DEPARTMENT OF ENERGY

Federal Energy Regulatory Commission

[Docket No. RM13-11-000]

Frequency Response and Frequency Bias Setting Reliability Standard

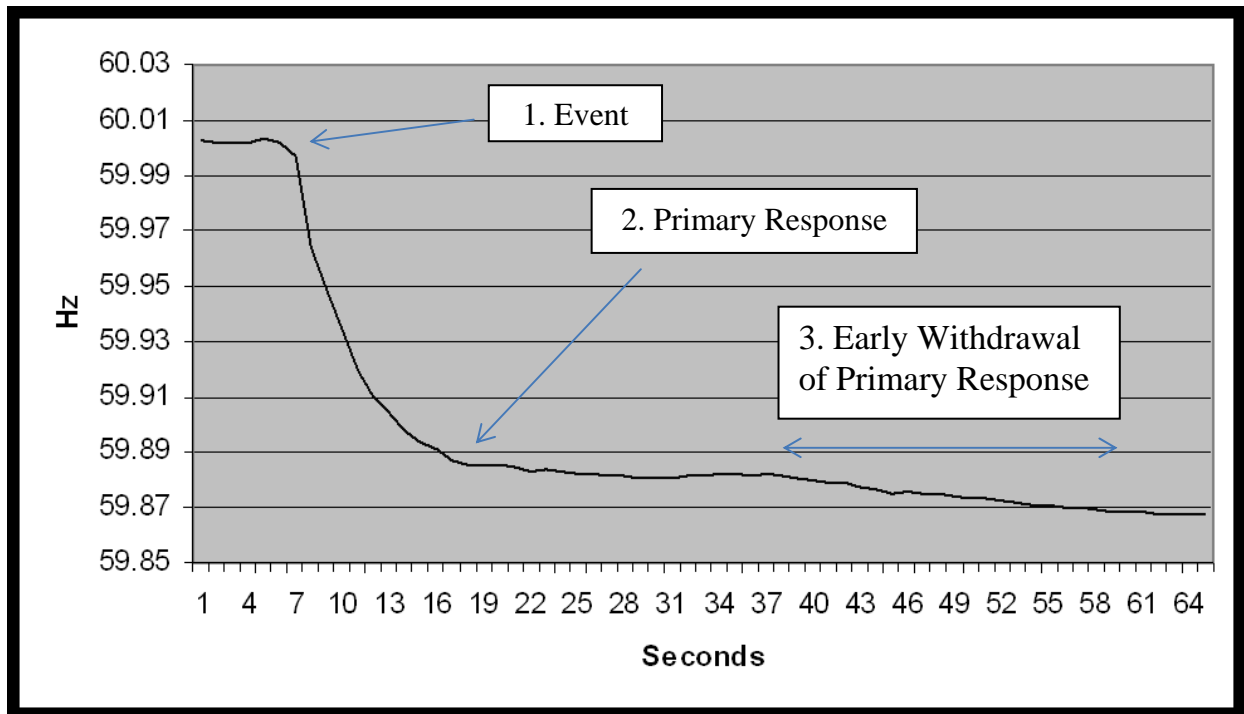
further drop in frequency response will occur. This drop in frequency is illustrated by the following diagram:⁵³

36. NERC indicates that, while the standards drafting team addressed the early withdrawal of primary frequency response, there are no requirements that address this issue and it remains a concern.⁵⁴ Specifically, during the initial recovery from the loss of

a generator, a “gap” can occur if significant amounts of primary frequency responses are withdrawn before the secondary response is fully activated. As previously noted, the Interconnection Frequency Response Obligation for each Interconnection is a function of the resource contingency criteria and the maximum change in frequency.⁵⁵ The Frequency Response Initiative Report recommends that an adjustment should be made to the maximum allowable change in frequency to compensate for the predominate withdrawal of primary frequency response exhibited in an Interconnection until such withdrawal is no longer exhibited.⁵⁶ NERC includes an adjustment to provide an additional primary frequency response when early withdrawal of primary frequency response would occur.⁵⁷ This adjustment only partially addresses the concern because, while increased primary frequency response is beneficial, it still does not address early withdrawal of primary frequency response that otherwise would allow time for secondary frequency response to prevent further decline in frequency. The Frequency Response Initiative Report also recommends that this adjustment should be carefully monitored and recalculated during the annual Interconnection Frequency Response Obligation
